**Steven M. Clouse WRC Electrical System Improvements Phase II**  
**Solicitation Number: CO-00276**  
**Job No.: 16-6501**

**ADDENDUM 3**  
**March 16, 2021**

SPLICE CABINET PAD

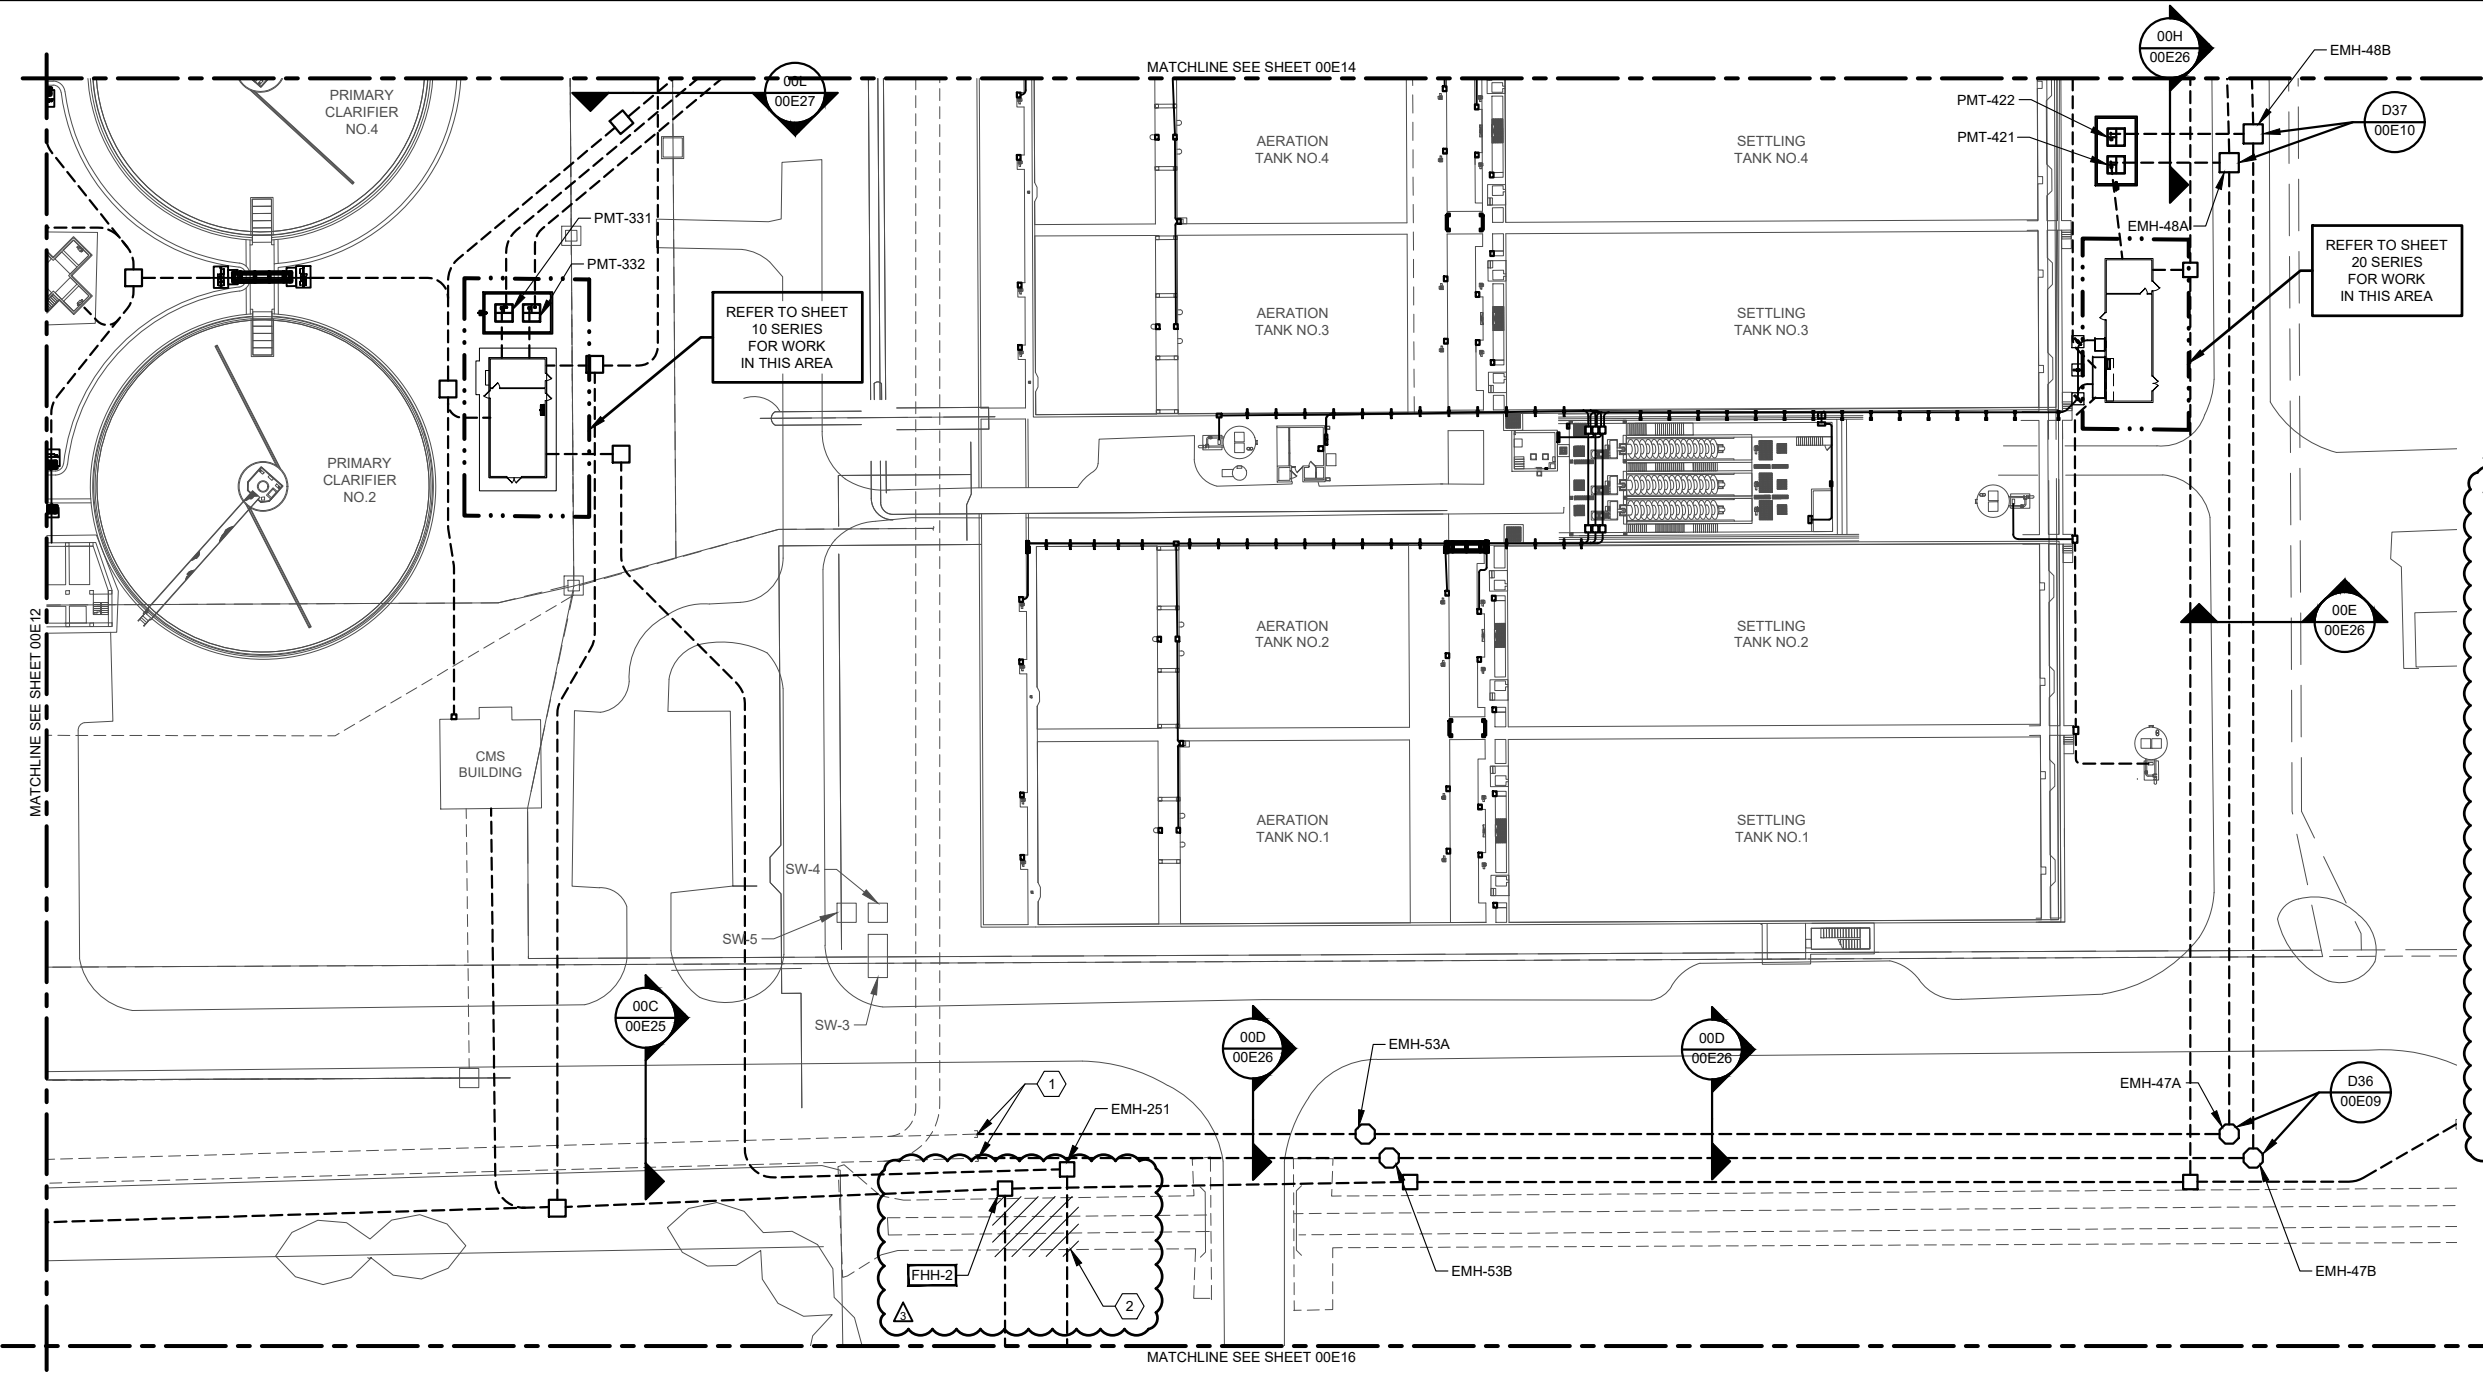
1. Sheet 00E12 through – 00E14, due to the length of circuits SGA-4P and SGB-4P would require splices along the route. As splices will need to be in the manholes, please clarify statement in Specification Section 16121 3.02 B 1 regarding the proposed above ground splice locations.

*Response: No splices are allowed in manholes. All feeders shall be installed without splicing, if possible. Aboveground splices shall be implemented using Medium Voltage Pad-Mounted Cable Switching and Terminating Stations. Refer to Specification 16121-2.01-C, page 16121-4 and specification Section 16335. Refer to “Changes to the Plans,” item 1.a for foundation details.*

SHEET NO.  
**00E16**  
40 OF 500

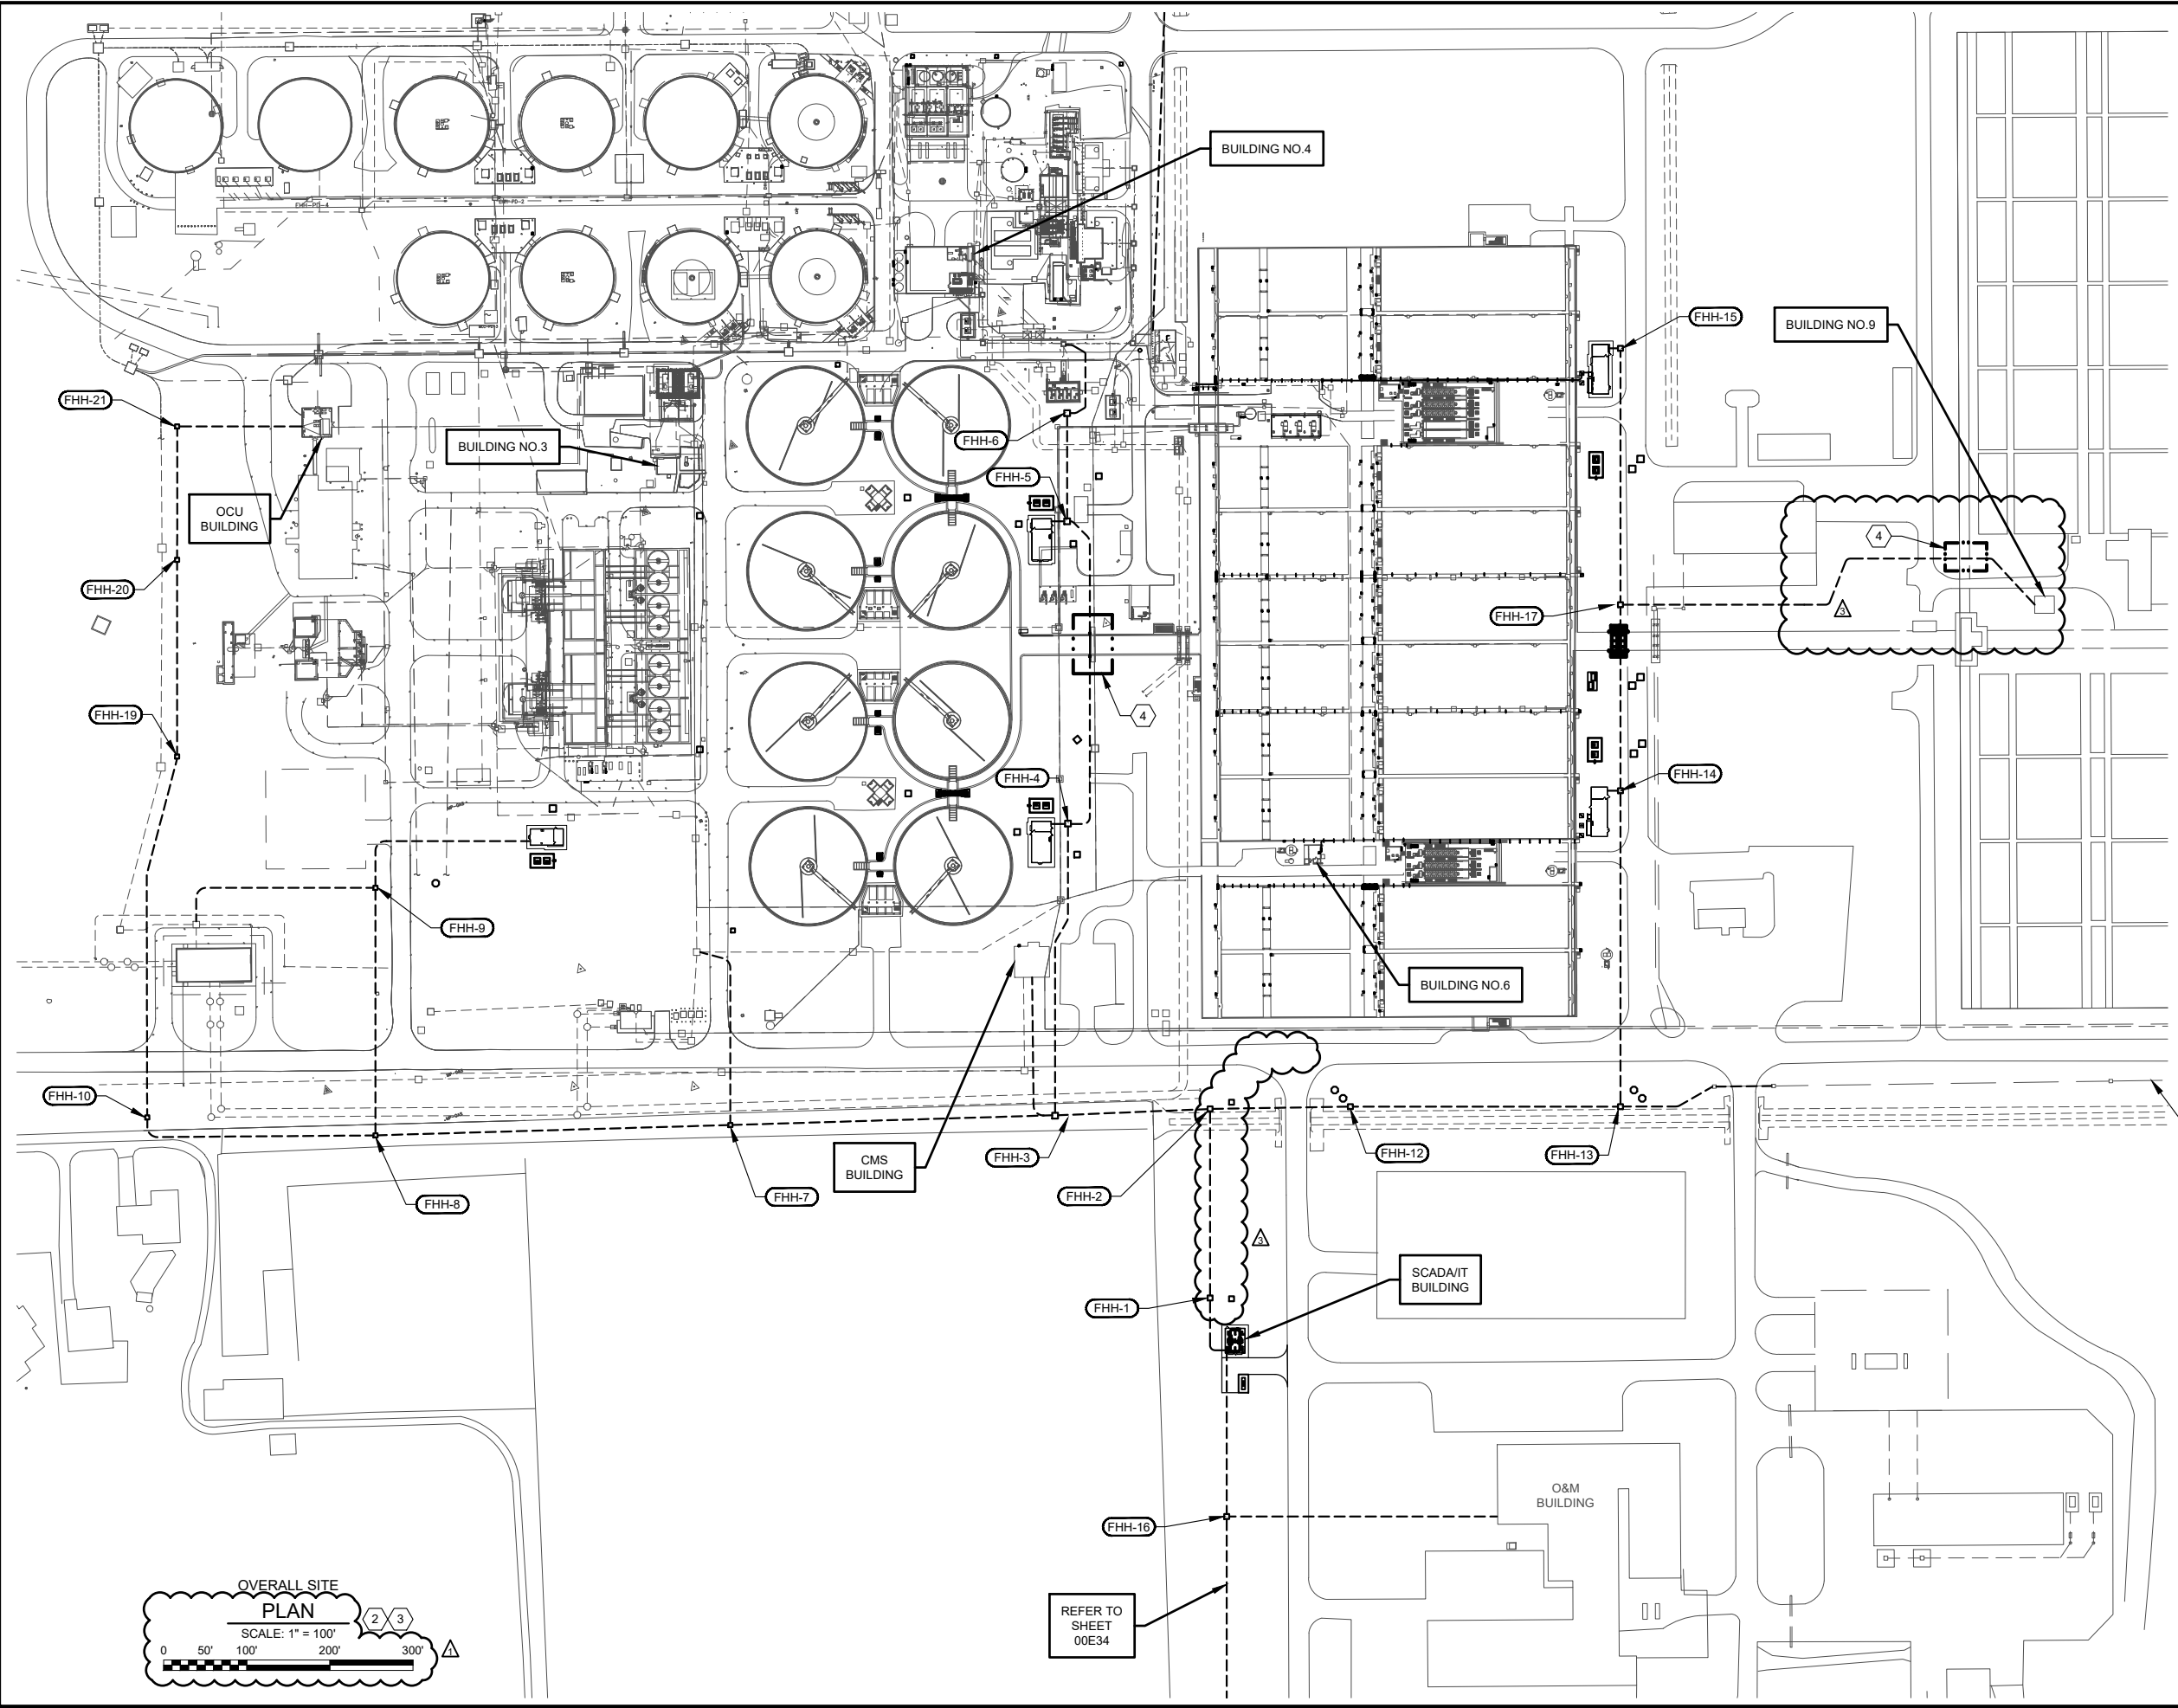
2. Sheets 00E16 & 00E33; ductbanks sections F20, F6, between handholes FHH-1 & FHH-2 & FHH-11(CHH-251) and ductbank section 40C(00R) between EMH-XX and EMH-251 from SCADA/IT building to the plant side will be required to cross the drainage ditch approximately 30’ long. However, there are no details regarding the crossing. Please provide details on how SAWS want the crossing to be accomplished.

*Response: Saw cut concrete channel, install ductbank, and repair cut. Refer to “Changes to the Specifications,” item 1. Refer to “Changes to the Plans,” items 1.b, 1.c, 1.d, 1.e, 1.f, 1.g, and 1.h. Cross-section detail of channel concrete is on sheet G-5, Project DR 83-6501 “Support Structures, Access Roads, & Miscellaneous Work, Contract 1” (June, 1983) available on request from SAWS.*

SHEET NO.  
**00E33**  
57 OF 500

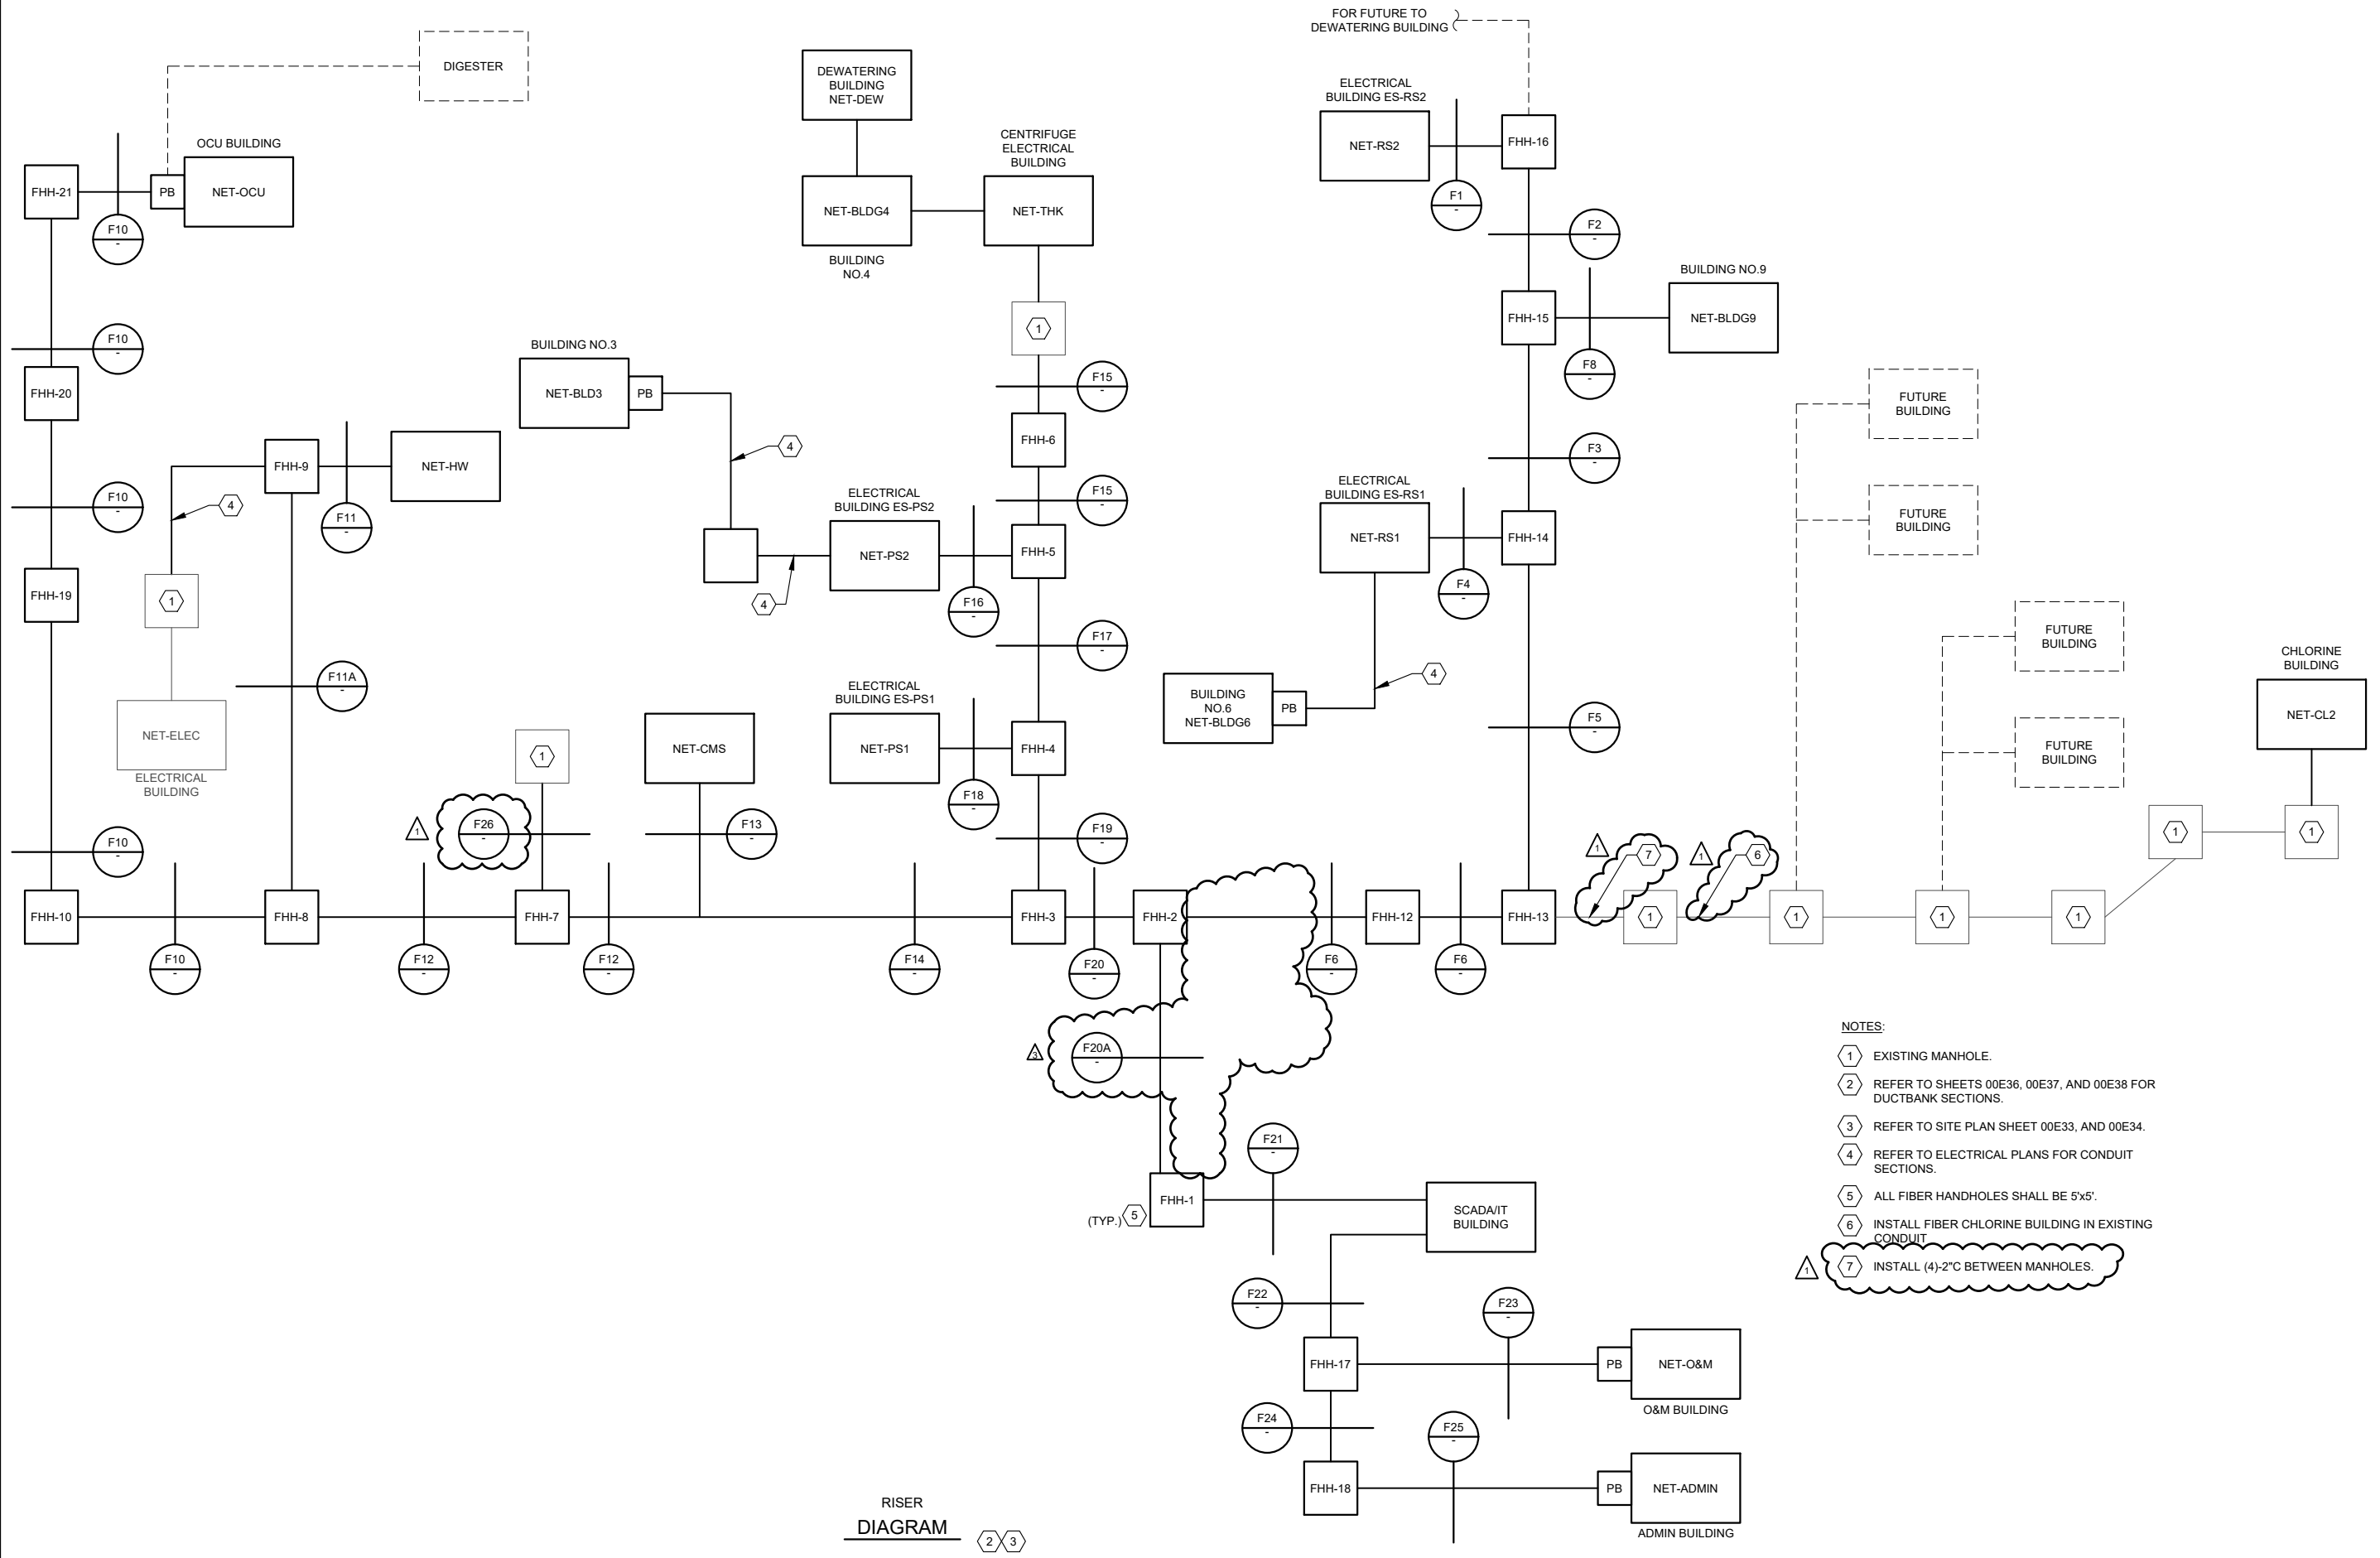
4. Sheet 00E33 ductbank section F8 to Building No. 9 will need to cross the channel just west of Building No. 9. Please provide details for the channel crossing. There are no handrails on the vehicle bridge to mount conduit support similar to detail shown on 00E43.

*Response: Route ductbank across channel at existing walkway with handrails. Refer to “Changes to the Plans,” item 1.d.*
